**Flood Control Project Maintenance
Levee Inspections**
LMA District Cover Sheet
Spring 2016 Levee Inspection Results

City of Sacramento

Waterway			Bank	Unit Miles
Unit No. 01 Sacramento River			Left	3.67
	Spring (March - May)	Summer (June - August)	(September - November) Fall	Winter (December - February)
Unit Maintenance Rating (Fall Only)				
Date of Inspection	3/8/2016 - 3/8/2016			
DWR Inspector	Jai Lor			
Accompanied By	Michael Gonsalves City of Sacramento

Levee Inspection Report By Mile - Spring 2016

Photo 1 of 1 : UCIP_SP_2016_41418_72741.jpg

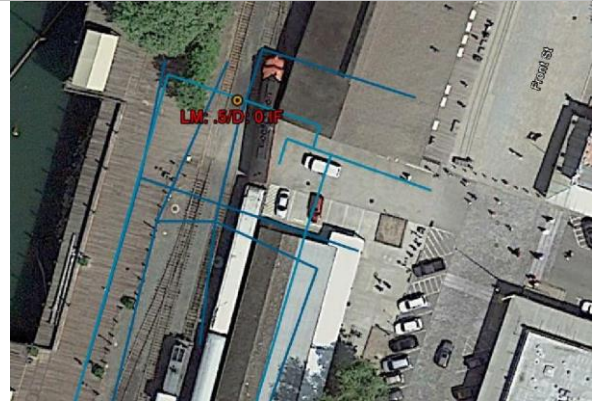
LM Start	0.50	Rating **	M	Issue No.	834
LM End	0.50	Issue Type +	En	Location *	WS
Category	Supplemental			GPS Latitude/Longitude	
				Start	End
Item	DWR UCIP Field Study			38.583693 °	38.583693 °
				-121.505909 °	-121.505909 °
DWR ID					
Comment Code					
Inspector Comment					
FS_ID:41418 DS_ID:24894 EP_NO: N/A Repair Type: Non-Urgent Crossing Status: Indicator Found UCIP Comments: Need to confirm status of crossing and alignment through levee. Unable to find permit during review. FIELD_STRUCT_DESC: 8 inch pipe through levee and along waterward side for about 800 feet. Crosses levee again at 38.581544, -121.506688. FS Date: 3/6/2013

Aproximate alignment provided by City of Sacramento -- unable to confirm if crossing is active.

Photo 1 of 1 : UCIP_SP_2016_41419_72742.jpg

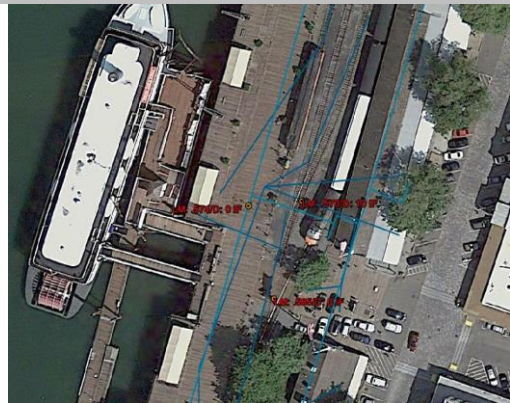
LM Start	0.57	Rating **	M	Issue No.	835
LM End	0.57	Issue Type +	En	Location *	WS
Category	Supplemental			GPS Latitude/Longitude	
				Start	End
Item	DWR UCIP Field Study			38.582700 °	38.582700 °
				-121.506266 °	-121.506266 °
DWR ID					
Comment Code					
Inspector Comment					
FS_ID:41419					
DS_ID:24895					
EP_NO: N/A					
Repair Type: Non-Urgent					
Crossing Status: Indicator Found					
UCIP Comments: Need to confirm if crossing is still present. No signs visible during site visit. No photos available.					
FIELD_STRUCT_DESC: 10 inch line through levee. Record found in Sacramento County GIS records.					
FS Date: 3/6/2013

Approximate alignment provided by the City of Sacramento--unable to confirm crossing in field.

Photo 1 of 2 : SP_2016_NA0005_251_1_20160304_00001.jpg

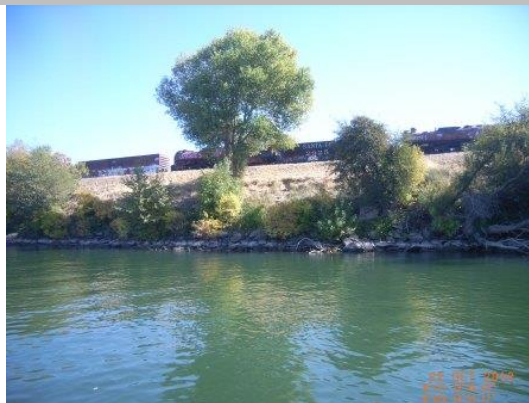
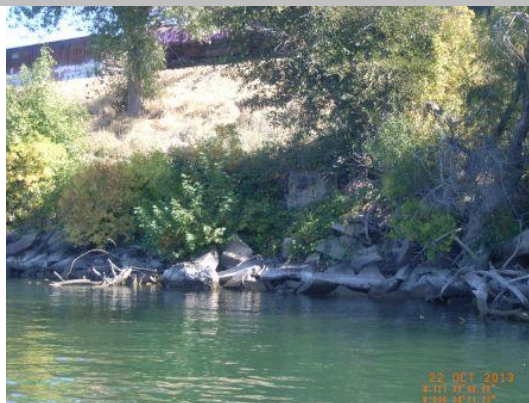
LM Start	1.31	Rating **	M	Issue No.	1
LM End	1.39	Issue Type +	Ma	Location *	WS
Category	Supplemental			GPS Latitude/Longitude	
				Start	End
Item	2015 USACE Erosion Survey, DRAFT			38.573169 °	38.572277 °
				-121.511998 °	-121.513063 °
DWR ID	DWR_NA0005_01_s _ 2016_1				
Comment Code					
Inspector Comment					
2008 - Oversized levee, should be repaired under maintenance. 2009 - Shallow slumps at the mid bank. 2010 - Some minor erosion at the toe, likely from wave wash. Some new shallow slumps. 2011 - One new tree has fallen. 2013 - Erosion continues on the slope surface, site extended upstream. 2015: No observed changes. [2015 Site ID: SAC_58-5_L]

Photo 1 of 2 : UCIP_SP_2016_20087_34024.jpg

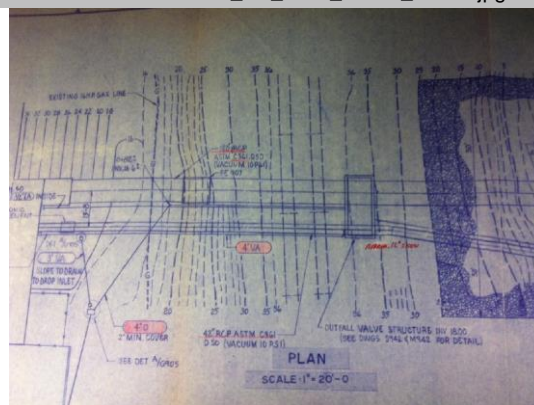
Comment Code					
Inspector Comment					
FS_ID:20087 DS_ID:22483 EP_NO: 12196 Repair Type: Non-Urgent Crossing Status: Found UCIP Comments: Vault located on levee crown (bike path) and siphon breaker located on waterward shoulder. Coordinate with City of Sacramento to determine the condition of this crossing and last inspection. FIELD_STRUCT_DESC: 1 or 2: 42-inch RCP wash water intake pipe through levee at approximately 10 feet below crown. Line extends approximately 145 feet waterward from the reservoir to the outfall structure at the waterward shoulder of the levee. Pipe is skewed approximately 12 degrees upstream. Water Intake structure with screen. Waterward slope is armored by rock slope protection. Rock slope protection perimeter exists at river intake. (Permit No. 12196, Sacramento Regional County Sanitation District-1981). Permit 16611 was issued in 1996 to reline the inside of the pipe. FS Date: 3/6/2013

DWG showing 42-inch and 120-inch pipes through levee and connection to outfall valve structure.

Photo 2 of 2 : UCIP_SP_2016_20087_34027.jpg

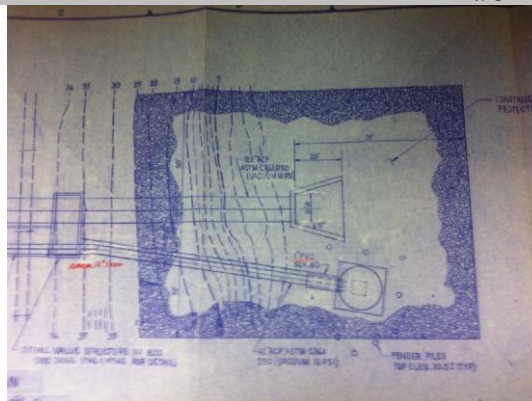
Comment Code					
Inspector Comment					
FS_ID:20087 DS_ID:22483 EP_NO: 12196 Repair Type: Non-Urgent Crossing Status: Found UCIP Comments: Vault located on levee crown (bike path) and siphon breaker located on waterward shoulder. Coordinate with City of Sacramento to determine the condition of this crossing and last inspection. FIELD_STRUCT_DESC: 1 or 2: 42-inch RCP wash water intake pipe through levee at approximately 10 feet below crown. Line extends approximately 145 feet waterward from the reservoir to the outfall structure at the waterward shoulder of the levee. Pipe is skewed approximately 12 degrees upstream. Water Intake structure with screen. Waterward slope is armored by rock slope protection. Rock slope protection perimeter exists at river intake. (Permit No. 12196, Sacramento Regional County Sanitation District-1981). Permit 16611 was issued in 1996 to reline the inside of the pipe. FS Date: 3/6/2013

Rip rap protection around outfall structure for 42-inch and 120-inch pipes.

Photo 1 of 1 : UCIP_SP_2016_41296_72767.jpg

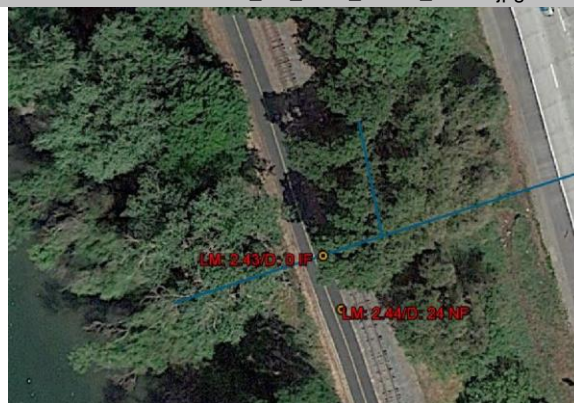
LM Start	2.43	Rating **	M	Issue No.	860
LM End	2.43	Issue Type +	En	Location *	WS
Category	Supplemental			GPS Latitude/Longitude	
				Start	End
Item	DWR UCIP Field Study			38.558224 °	38.558224 °
				-121.514365 °	-121.514365 °
DWR ID					
Comment Code					
Inspector Comment					
FS_ID:41296 DS_ID:24927 EP_NO: N/A Repair Type: Non-Urgent Crossing Status: Indicator Found UCIP Comments: Need to coordinate with owner to determine status of crossing--unable to locate in field. FIELD_STRUCT_DESC: 18 inch storm drain at unknown depth. Crossing information was obtained from Sacramento County GIS records. FS Date: 3/6/2013

Approximate alignment of crossing provided by the City of Sacramento.

Photo 1 of 1 : SP_2016_NA0005_251_2_20160304_00003.jpg

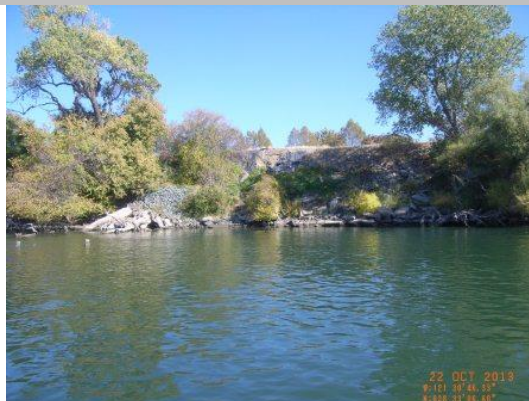
LM Start	2.85	Rating **	M	Issue No.	2
LM End	2.90	Issue Type +	Ma	Location *	WS
Category	Supplemental			GPS Latitude/Longitude	
				Start	End
Item	2015 USACE Erosion Survey, DRAFT			38.552268 °	38.551578 °
				-121.512590 °	-121.512336 °
DWR ID	DWR_NA0005_01_s _ 2016_2				
Comment Code					
Inspector Comment					
1997 - Erosion at pump station, concrete debris and plastic showing. 2000 - Separation scour of bank due to poor transition. 2004 - New large tree pop out; city dumped fill dirt/rock into hole. 2006 - Minor new erosion at top of bank. 2010 - Some new rock placed in tree pop-out. 2011 - A large tree has fallen and flood fighting was performed by the city on the upper levee slope. 2012 - Small rock placed in hole from tree popout. 2015: No observed changes. [2015 Site ID: SAC 56-6 L]

Photo 1 of 1 : SP_2016_NA0005_251_9_20160304_00008.jpg

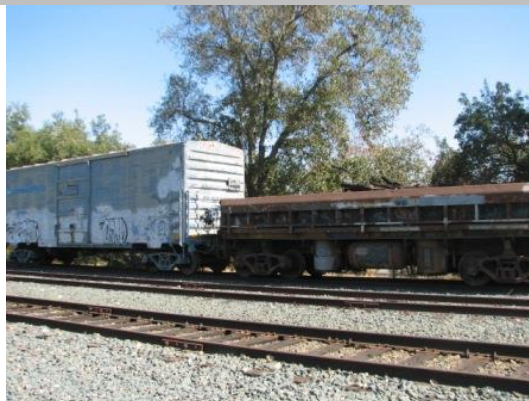
LM Start	3.29	Rating **	M	Issue No.	9
LM End	3.29	Issue Type +	En	Location *	CR
Category	Earthen Levee			GPS Latitude/Longitude	
				Start	End
Item	Encroachments			38.546302 °	38.546302 °
				-121.510197 °	-121.510197 °
DWR ID	DWR_NA0005_01_f_2013_9				
Comment Code					
EQ : Equipment					
Inspector Comment					
There are four cars on the levee crown.

Trains cars are stored on the crown of the levee. Fall 2013
